cook farm
further lane mellor

visibility

drg.no. 1939 / 10 rev. D
na dec.19 1 to 500 @ A1
drawn. date. scale.

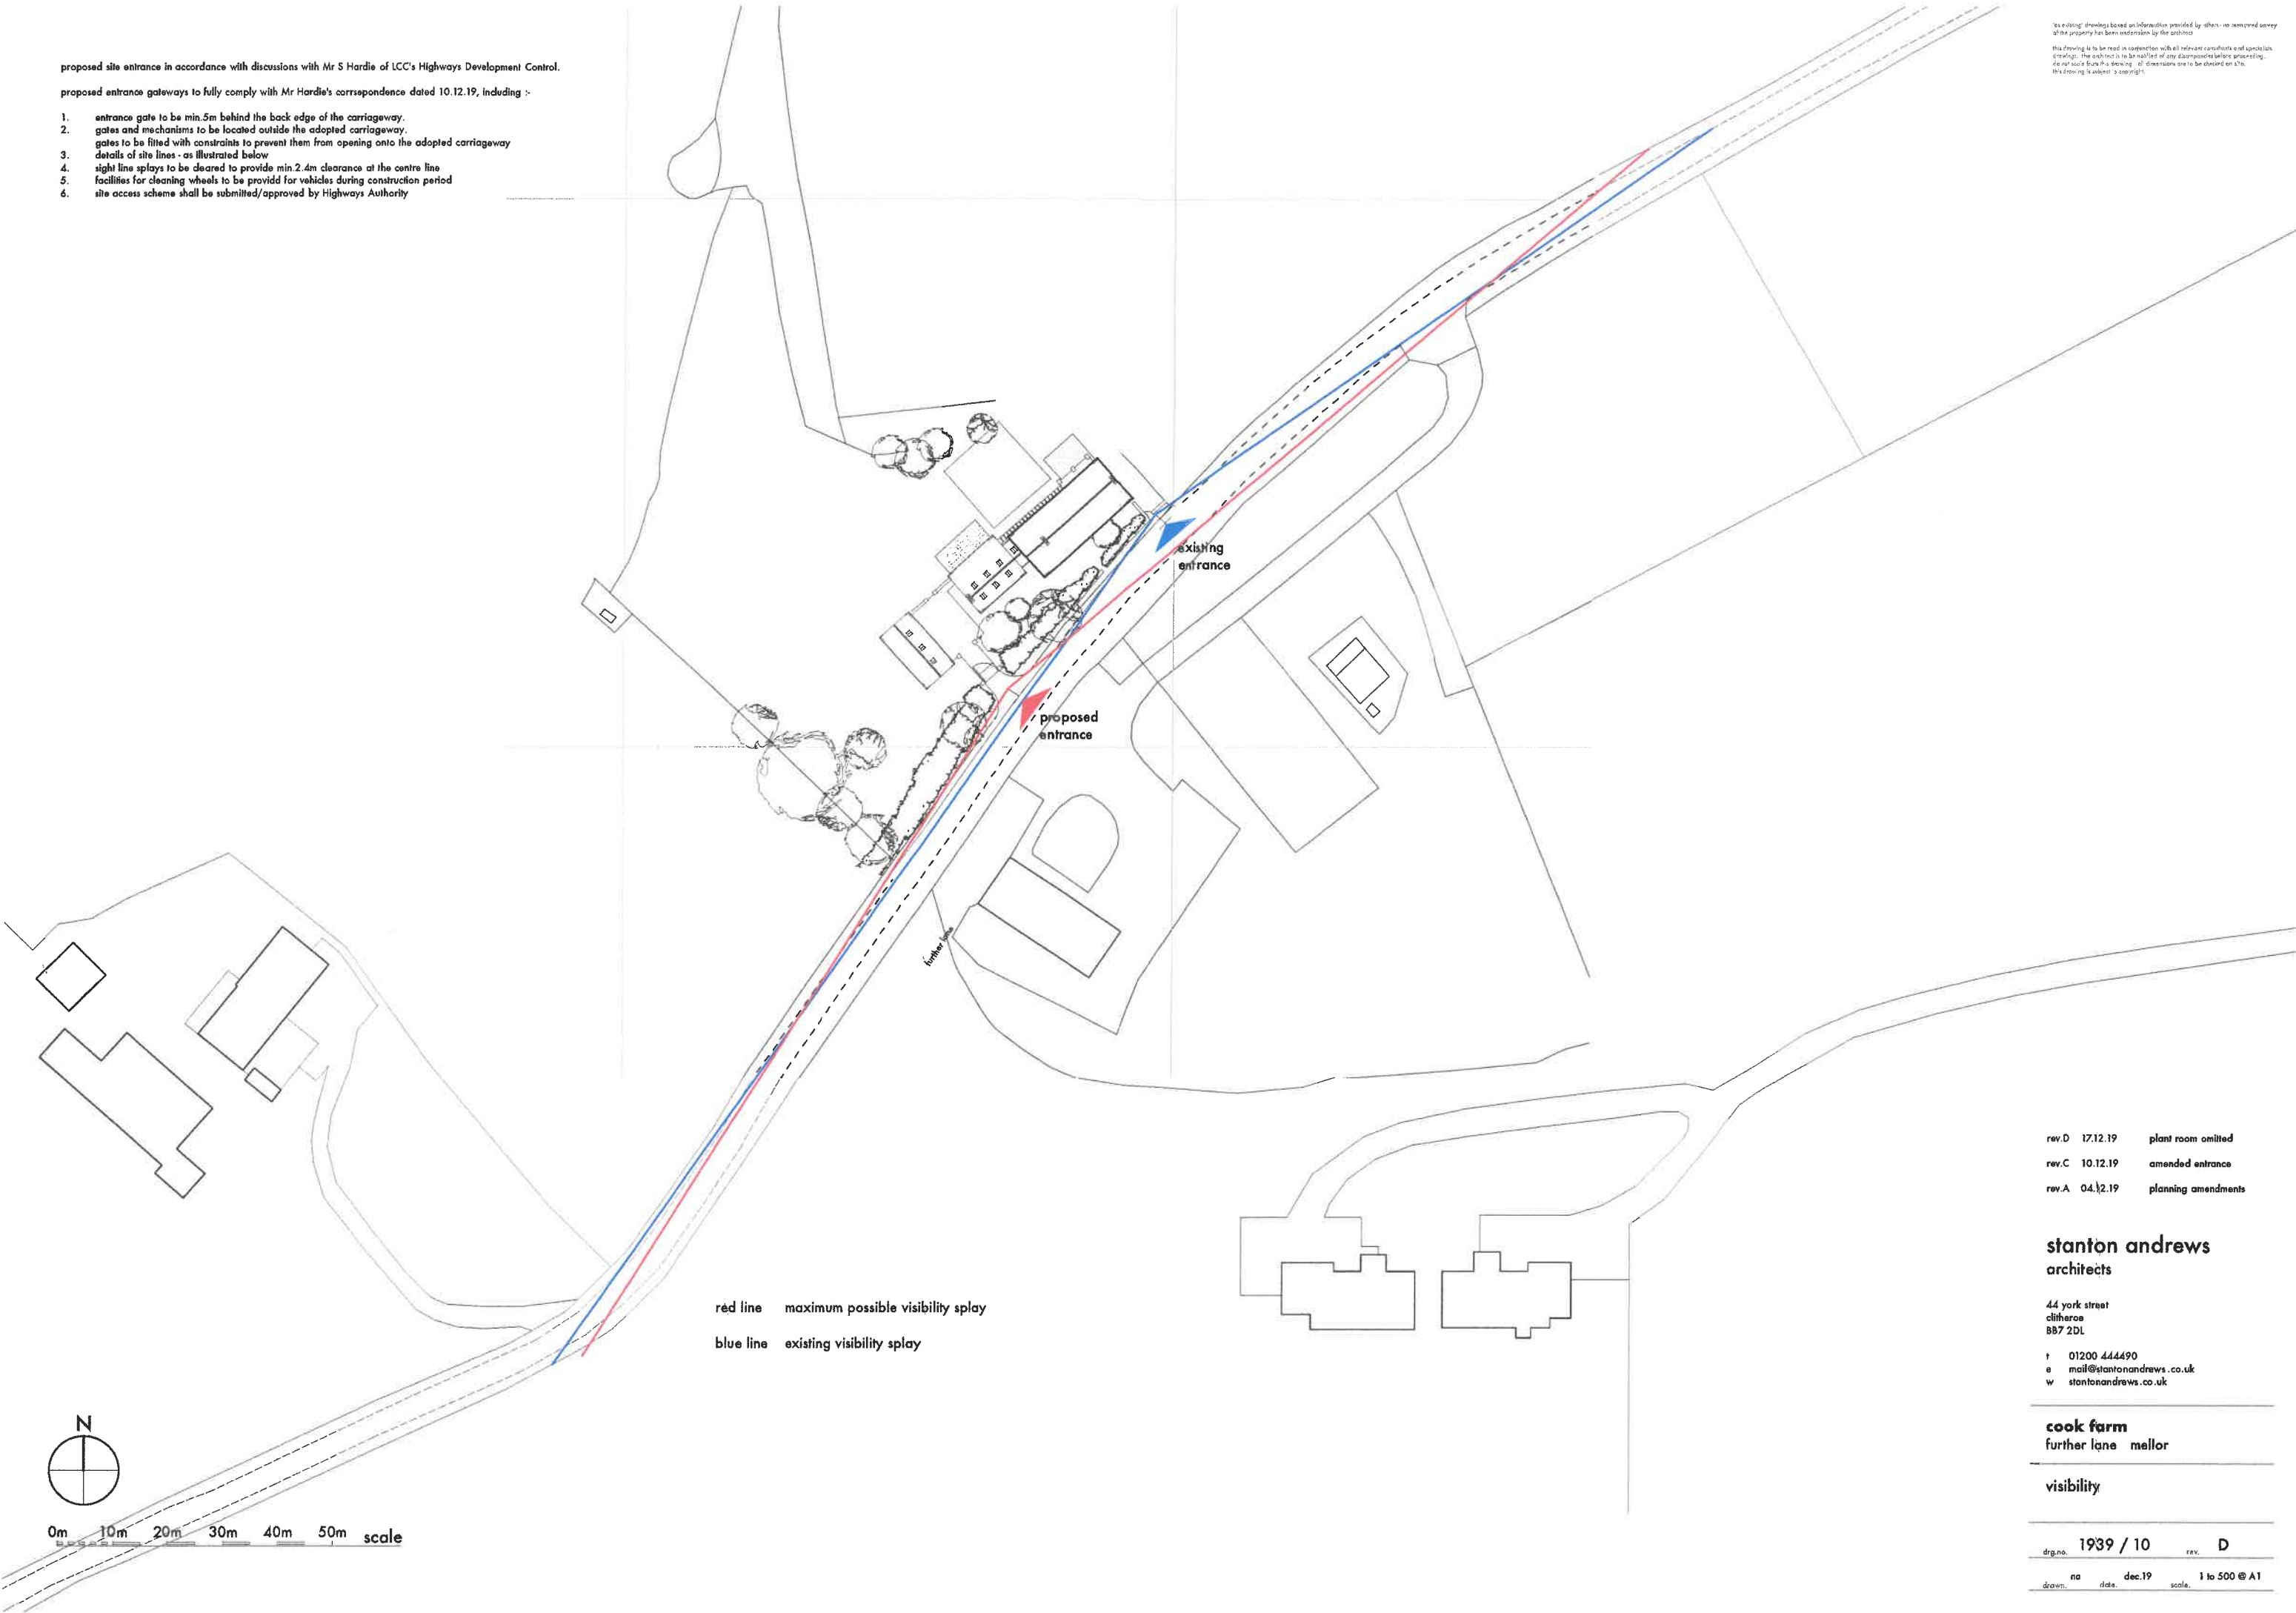
proposed site entrance in accordance with discussions with Mr S Hardie of LCC's Highways Development Control.

proposed entrance gateways to fully comply with Mr Hardie's correspondence dated 10.12.19, including :-

- 1. entrance gate to be min.5m behind the back edge of the carriageway.
- 2. gates and mechanisms to be located outside the adopted carriageway.
- 3. gates to be fitted with constraints to prevent them from opening onto the adopted carriageway
- 4. details of site lines - as illustrated below
- 5. sight line splays to be cleared to provide min.2.4m clearance at the centre line
- 6. facilities for cleaning wheels to be provided for vehicles during construction period
- 6. site access scheme shall be submitted/approved by Highways Authority
